Rezoning Transportation Analysis

Petition Number: 2021-178

General Location Identifier: 07706303

Date	Description
11/21/2021	First Review (PDM)
12/20/2021	Second Review (PDM)
01/27/2022	Third Review (PDM)
03/02/2022	Fourth Review (PDM)

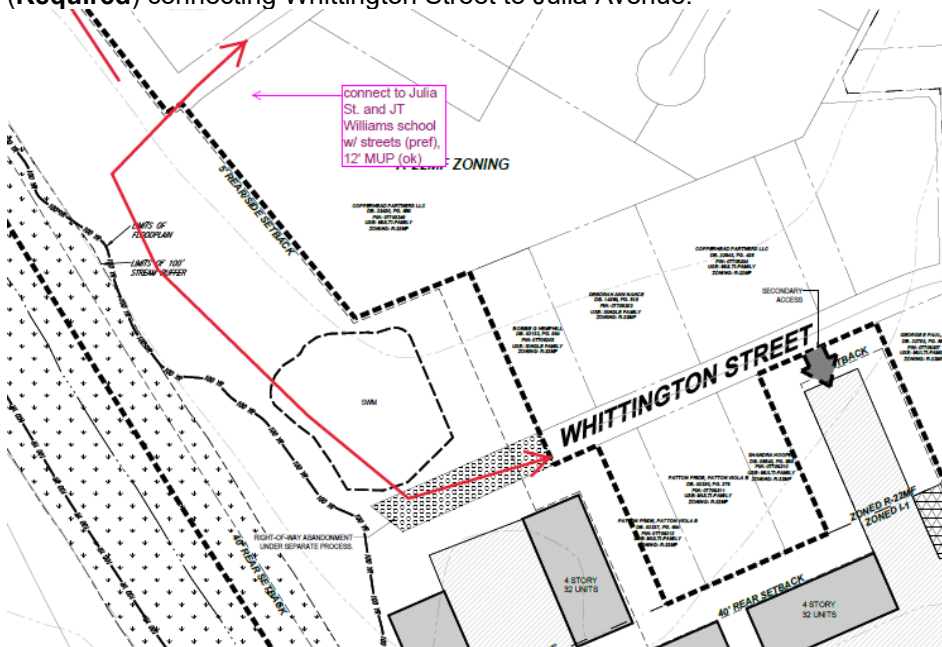
3. ~~Revise site plan and conditional note(s) to commit to dedicate 28 feet of right-of-way from the road centerline of Whittington Street. The site plan shall label and dimension the right-of-way from the road centerline.~~
~~Outstanding Comments from 11-21-21:~~ Show centerline of Whittington Street on site plan and dimension the proposed ROW from the centerline.

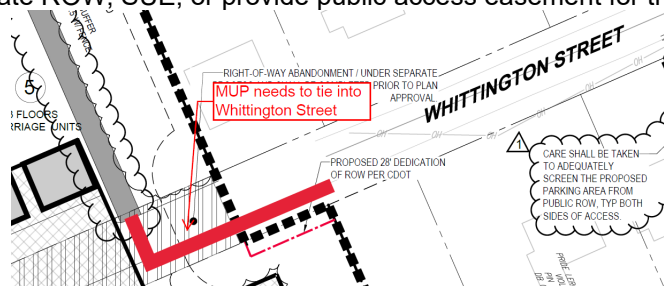
11. ~~**Outstanding Comments from 11-21-21:** Revise site plan and conditional note(s) to commit to installing a local residential median street per CLDSM U-02 (**Request**) or a 12-foot multi-use path (**Required**) connecting Whittington Street to Julia Avenue.~~

~~**Clarifying Comments from 1-27-22:** Extend MUP to Whittington Street. MUP needs to tie into the existing street. Dedicate ROW, SUE, or provide public access easement for the MUP.~~
